June 17, 2020

**TO:** Planning Commission Members

**FROM:** Jillian Dierks, Planner, Department of Building & Planning

**SUBJECT: TENTATIVE SKETCH PLAN – 104, 108, 114, 120, 124, 130, 150 & 198 W. Lancaster Avenue, Ardmore, 3843TS, Ward 4**

Proposed Pedestrian Facilities  
Ardmore Ave & W. Athens Ave. - June 2020

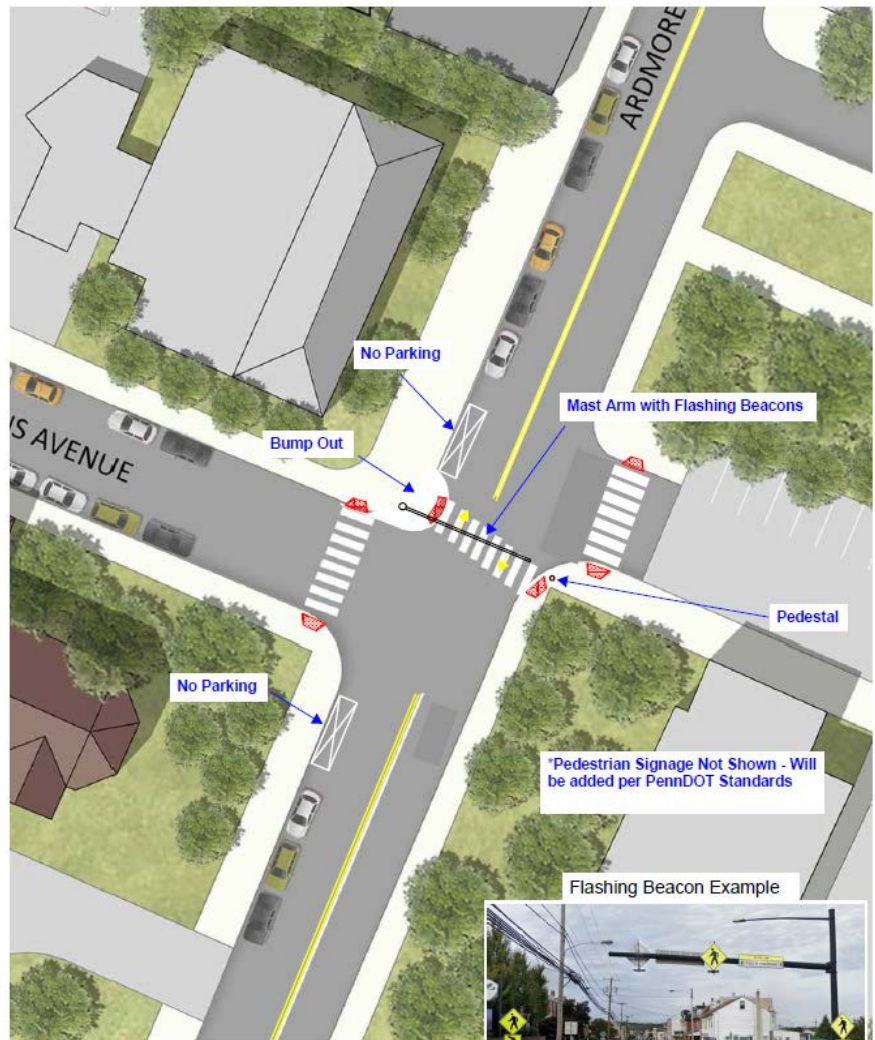
**Safety Improvements to Ardmore Avenue:** As noted above the applicant participated in an on-site meeting with staff, PennDot, Senator Leach, Lower Merion Traffic Safety Department and Public Works to discuss the pedestrian crosswalk near Ardmore House and pedestrian safety issues on Ardmore Avenue following the tragic pedestrian fatality on Ardmore Avenue in February. The plans show pedestrian features such as:

- An activated pedestrian beacon is shown in the crosswalk;
- Crosswalks have been relocated/improved/enhanced;
- A pedestrian bump-out has been added at the corner of W. Athens Avenue and Ardmore Avenue adjacent to the post office to decrease the distance of street that pedestrians are required to cross,
- Parking has been restricted in the area adjacent to the intersection to increase pedestrian visibility.

Staff is looking to also coordinate the pathways from Ardmore House to the intersection to facilitate safe usage and a comfortable pedestrian experience.
